POINT BEACH NUCLEAR PLANT INDIVIDUAL PLANT EXAMINATION
TECHNICAL EVALUATION REPORT
(FRONT-END)

**Point Beach 1 and 2 Technical Evaluation Report
on the Front End IPE Submittal**

Technical Evaluation Report
NRC-04-91-066, Task 22

Science and Engineering Associates, Inc.

Figure A-3. Mass Flow Rates for Feed and Bleed

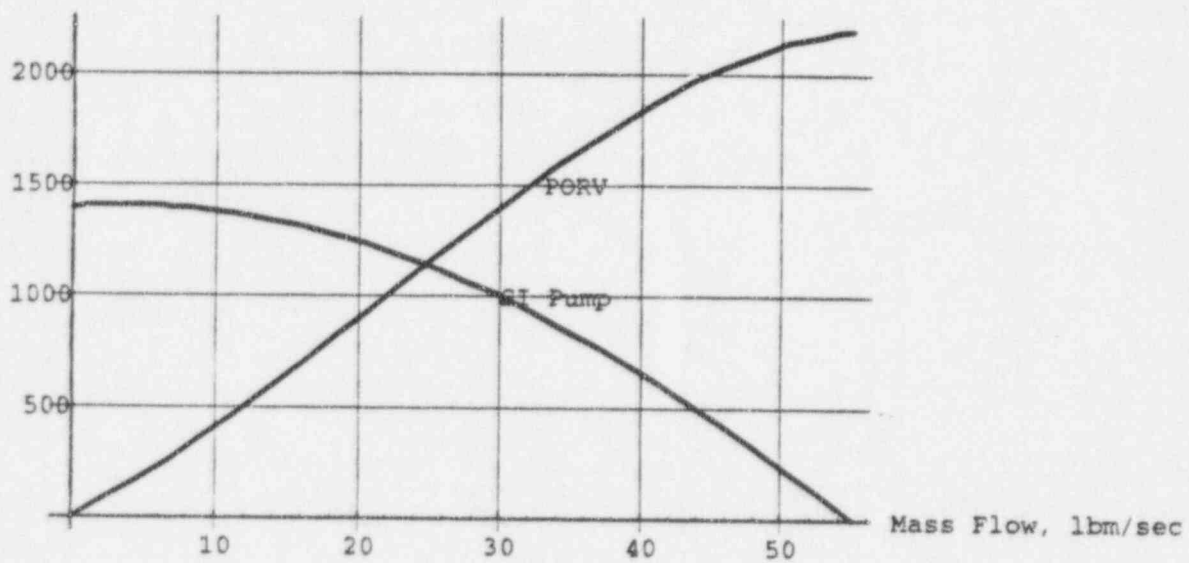
We evaluated the ability to feed and bleed. Based on Figure 14.3.1-1 of the UFSAR and information on PORV relief capability from the Submittal in Section 3.1.4.1, we generated Figure A-3 using the interpolating polynomial curve fitting capabilities of Mathematica. We assumed that the pressurizer will be steaming when the vessel level drops sufficiently to uncover the pressurizer surge line in the hot leg.

The curve for PORV relief as a function of pressure is based on a Moody model with an effective PORV area calculated from the data in the Submittal for relief capability at a given pressure. Figure A-3 indicates that the 'match' point for makeup and loss is 25 lbm/sec at 1150 psia. Assuming feed with 100 F water and steaming out the PORV at 1150 psia, the heat that can be removed is

where m_r is the mass flow rate and h is enthalpy. Using Figure A-1 of this report, it is concluded that feed and bleed with one SI pump and one PORV can match decay heat at 25 minutes. Since the time to steam generator dryout is about 30 minutes, [IPE, Section 3.1.4.1] the feed and bleed criteria are reasonable.

Figure A-4. Probability of Non-Recovery of Offsite Power

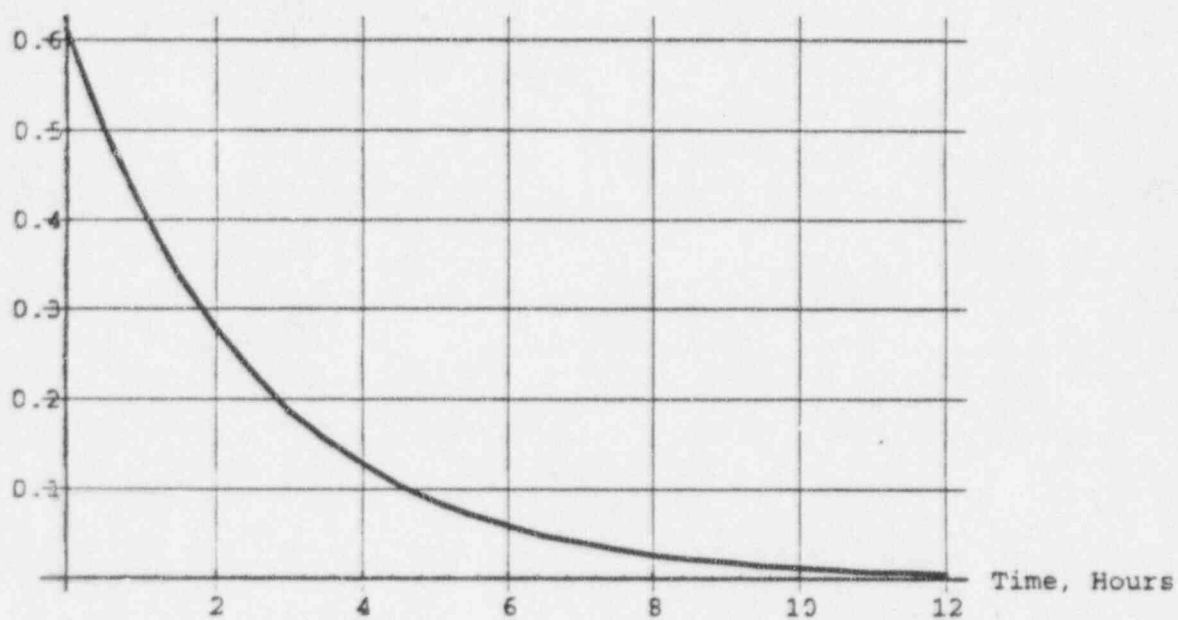
This curve cannot be correct at short times. For example, the curve indicates a probability of non-recovery of 0.61 at time 0 which cannot be right; at time 0 the probability must be 1.0. For times of about an hour or later the data from the curve agrees with typical non-recovery data. We conclude that the curve fit used did not fit the data for early times. The licensee responded that the curve for non-recovery of offsite power does not apply for early times; the likelihood of core uncover prior to 30 minutes was taken as 0.0 based on the seal LOCA model. [IPE Responses]

Figure A-5. Probability of RCP Seal LOCA

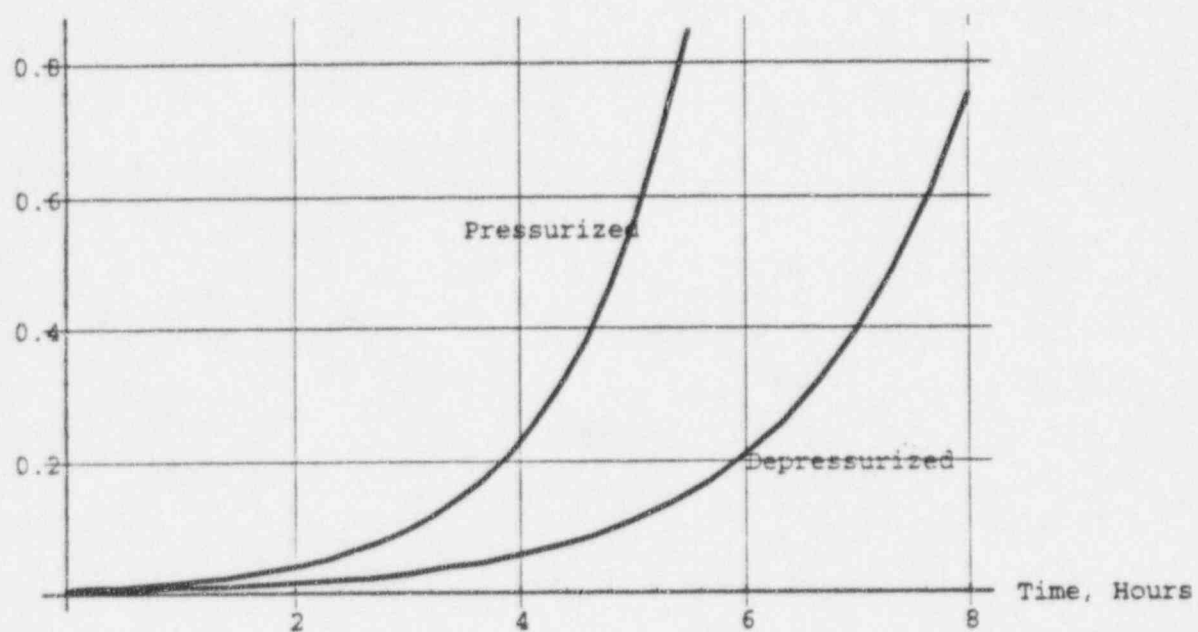
That is, seal failure by time t corresponds to core uncover by time t+3. A plot of equation (IV) is given in Figure A-5 for the two cases, pressurized and depressurized, using the values for a and b in the Submittal. Equation (IV) is the model used in the Submittal for the probability of a seal LOCA as a function of time after loss of all seal cooling. Note that this model indicates that the probability of a seal LOCA is small for times less than about 4 hours.

Evidently the upper limit in equation (X) is intended to be $t_i - 3$ where t_i is the sequence-specific time for core uncover without off-site power if no RCP seal LOCA occurs. PROB-SL is based on the assumption that core uncover from a seal LOCA occurs 3 hours after the RCP seal LOCA; thus, RCP seal LOCAs within the time interval $(t_i - 3, t_i)$ do not contribute to core uncover within time t_i . However, an RCP seal LOCA within the time interval $(t_i - 3, t_i)$ does affect the time to core uncover by increasing the mass loss from the primary system; in effect, the RCP seal LOCA reduces the time T . The model does not address this effect since it excludes consideration of a seal LOCA within time $(t_i - 3, t_i)$. One conservative way to address this issue is to use T instead of $t_i - 3$ as the upper limit of integration.

- (1) the integrand contains the error of equation (V)
- (2) the upper limit $t_i - 3$ is not correct.

The licensee responded to both these issues. [IPE Response] Calculations were redone with the error in equation (V) corrected and with the upper limit specified as T . The overall impact on the change in CDF was very small.
